OICA comments on EFV-08-03

Parameter: CO₂ / GHG emissions

Reference Documents:

EFV 07-02: CO₂ Emissions

Figure 1: example for relative CO2 rating

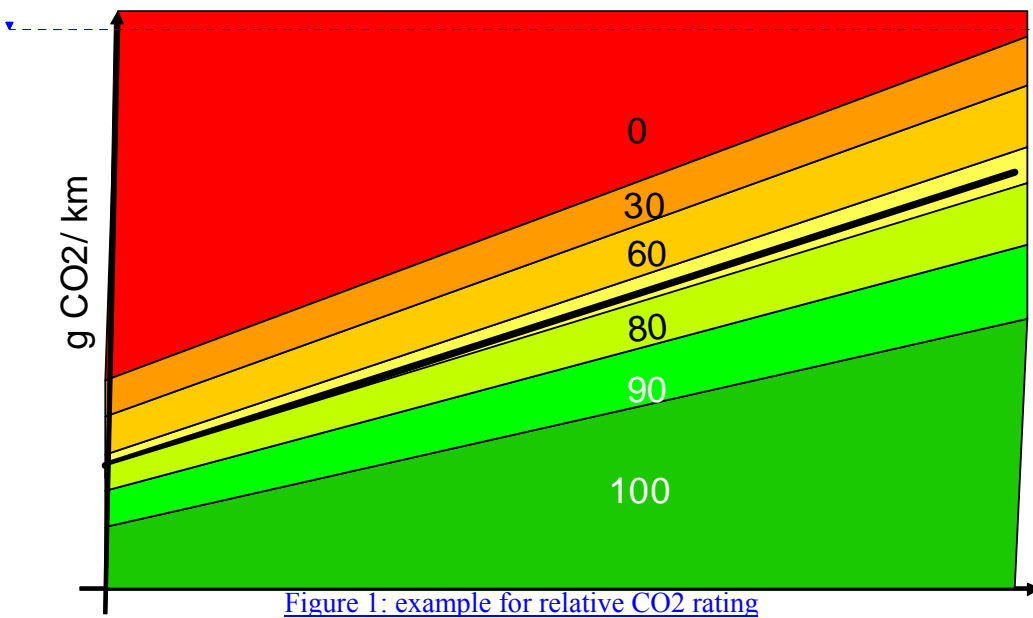
The base value for this approach has to been taken different for each region to reflect the specific vehicle needs. In no way any CO₂ value should be taken that is derived from a specific vehicle technology. Preferably the rating should be derived from the regional CO₂ regulation if applicable. Depending on the region these ratings are either absolute or relative.

Comment [WPS2]: Picking one vehicle technology is arbitrary. Why is a Hybrid a benchmark? Could be also advanced diesel, plug-in-hybrids etc.
